INDESIT company

Model type:
WITE107EU

Commercial code:
F034270

n1040345: Replacement of drum lock button TL EVOII.

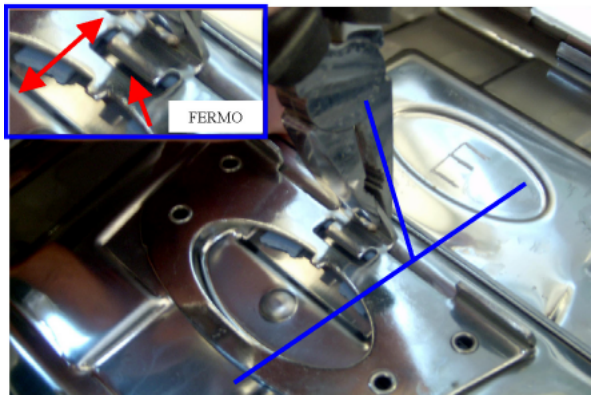
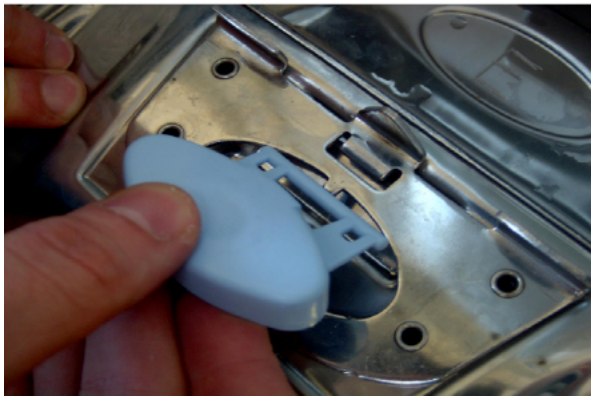
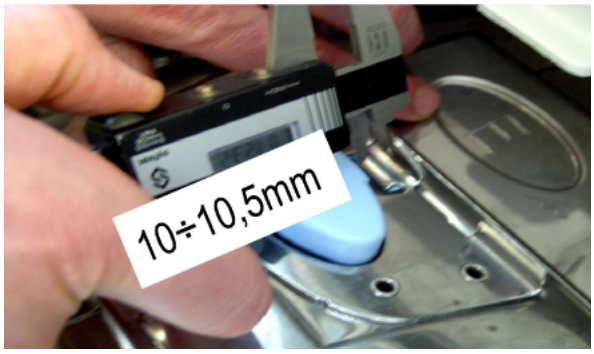
Tools and material needed: pliers, screwdriver, gauge, spring P/N Sat 114989, button P/N Sat 114990.

1) turn the central tip of the catch in the direction shown (FIG.1);

2) bring the tip to a vertical position and ensure that the broken button is disengaged from the catch restraint and can be removed (FIG.2);

3) remove the remaining part of the button with the aid of a screwdriver, taking care not to scratch the doors (FIG.3);

4) pre-assemble spring to button (FIG.4);

5) insert button between catch and door (FIG.5);

6) bring the button into position and arrange the spring in its location in the door (FIG.6);

7) turn the central tip of the catch in the direction shown to return it to its starting position (FIG.7);

8) check the distance between button and catch (FIG.8);

9) check correct operation of the button when opening and closing the doors (slight inclination errors of the catch can result in faulty closing of the doors) (FIG.9).

n1040382: Drain pump with bayonet-style filter - top Loading Brembate

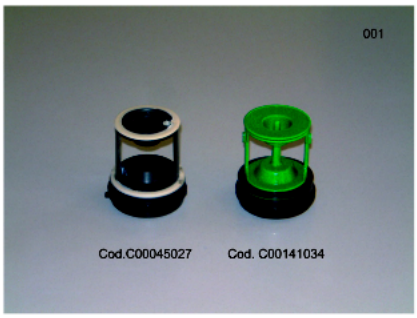
From serial no. 51021.0001 a new drain pump with bayonet-style filter has been installed on all top loading washing machines manufactured in Brembate.

New parts:
C00141862 - Drain pump
C00141034 - Pump filter kit

Premodification parts:
C00111409 - Drain pump
C00045027 - Pump filter kit

The new parts can be used instead of premodification ones.

N1040404FIG1

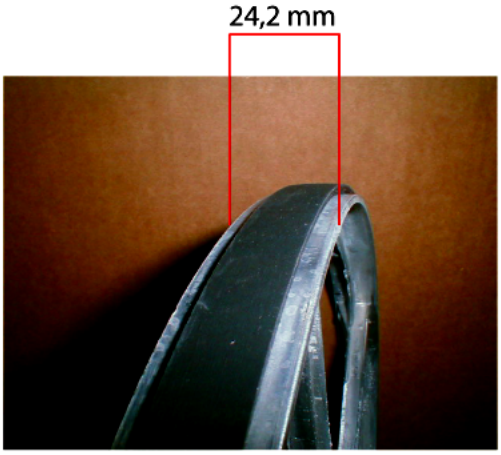
n1040404: New pulley installed on top loading washing machines up to 1000RPM (NO tub lock)

From serial no. 51202.0001 the pulley track has been widened from 21.2mm to 24.2mm (see picture N1040404FIG1).

new pulley
C00142832 - D280 24.2 mm track

Premodification pulley
C00083912 - D280 21.2 mm track

The new pulley can also be used on premodification versions of the models referred to in this release.
